Service Bulletin No. 348

MODEL E4500 / J4500 Series Coaches	TYPE Field Change Program	SECTION/GROUP 3- Body	DATE Aug. 16, 2010
SUBJECT SE – GI WINDOW GLASS ASSEMBLY ADHESIVE DEBONDING			
CONDITIONS

Ref. NHTSA Recall No.: 10V-373

Figure 1.

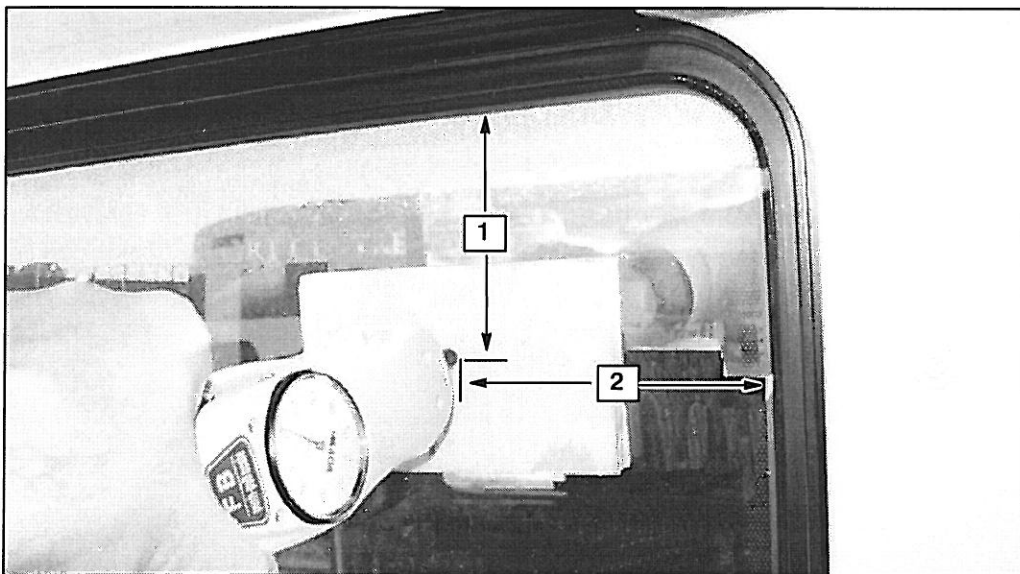
3. Ensure window is in locked position.
4. From inside the coach, carefully position a 4.0 x 4.0 x 0.5 inch flat wood block flat against the glass surface, the center of which should be six (6) inches from both edges (as shown in Figure 1). Position a push / pull gauge at the center of the wood block and apply 50 lbs. push force against the glass, perpendicular to the glass surface, to accentuate any partial de – bonding that may exist.
5. Look for any evidence of de-bonding from the frame, as force is applied.

6. Repeat Steps 3. to 5. at the remaining three (3) corner locations of the window.
7. Repeat Steps 3. to 6. to remaining coach windows.

Figure 2.

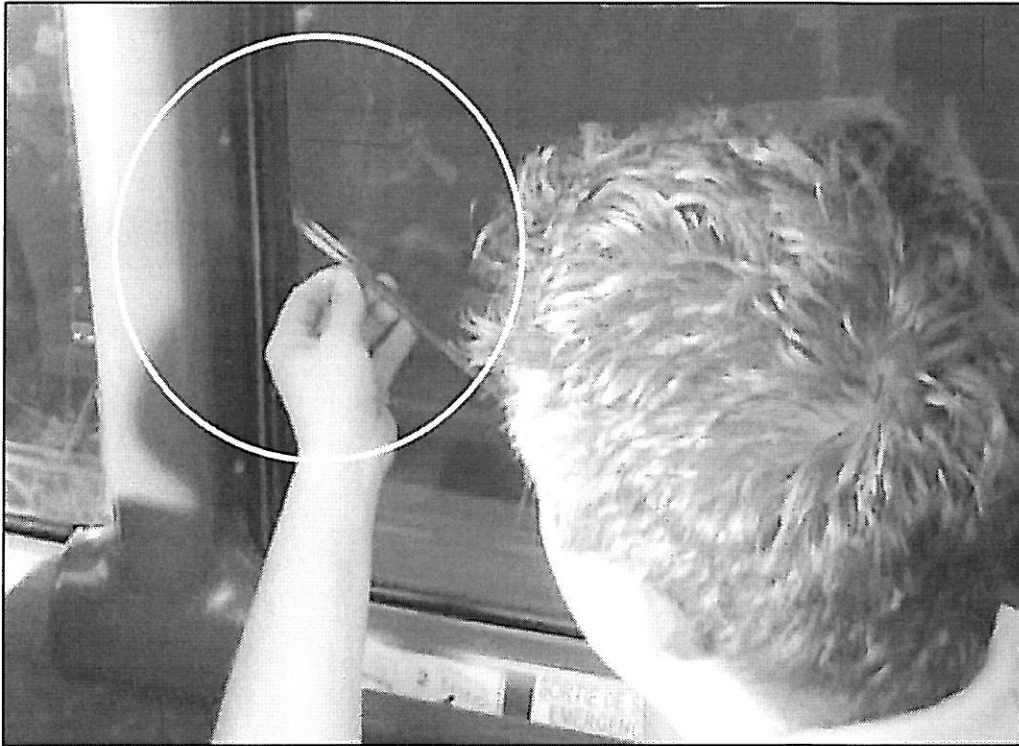
- Using a hook tool, remove the interior seal (from inside the coach cabin) from the de-bonded window by positioning the hook between glass and seal (refer to Figure 2). Pull up on the hook and turn counter-clockwise to remove seal from channel.

- Ensure all residue is removed from the 1/8 inch wide and 1/2 inch deep channel. Using an isopropyl alcohol and water mixture and lint-free cloths, clean the vacated channel.

- Apply Betaseal, p/n 23-06-0095, to fill the channel (gap).

- Using a lacing tool or trowel, compress and square-off the bead to ensure a clean edge.
- Repeat Steps 8. to 11. to remaining windows displaying evidence of de-bonding.
- Perform a push test on the window twenty four (24) hours after application, to ensure retrofit was performed correctly.

Figure 3.

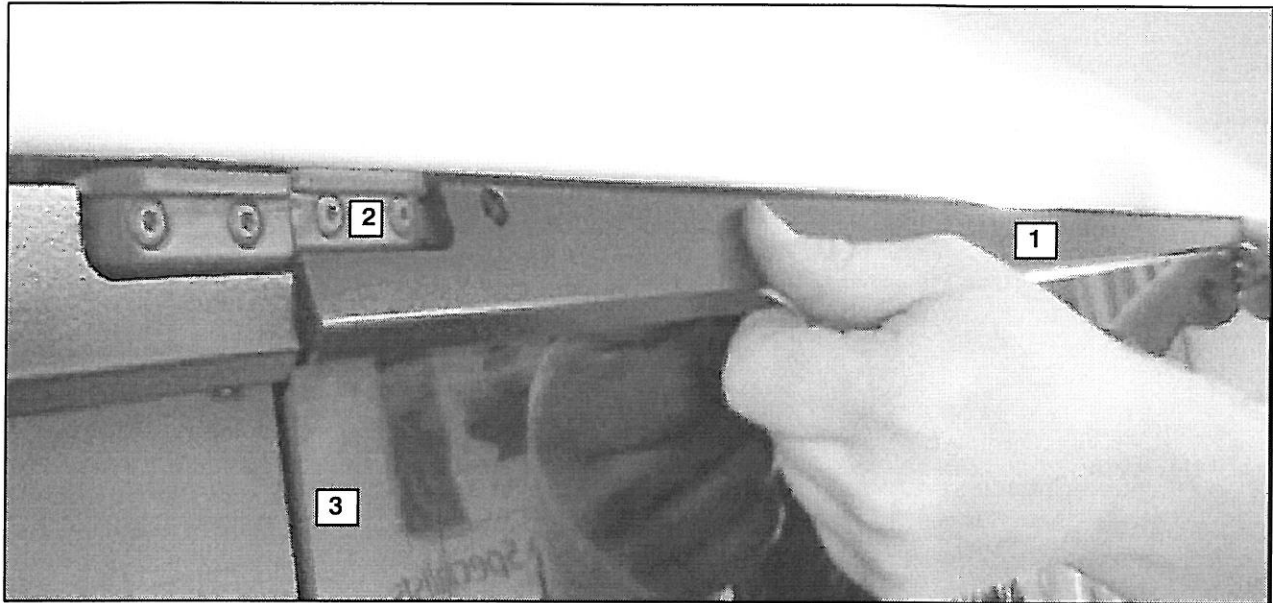
21. Align the hinge clip with the window (fore and aft) and swing the clip down until the double-sided tape contacts the glass (refer to Figure 3).

22. Using the hinge clip as a template, drill the center hole in the hinge clip. Install one (1) screw, p/n 19-01-2074, in the center hole of the hinge clip (refer to Figure 4).

23. Using the hinge clip as a template, drill the remaining holes in the hinge clip. Starting at the center and working out to the ends, secure to window using screws, p/n 19-01-2074.
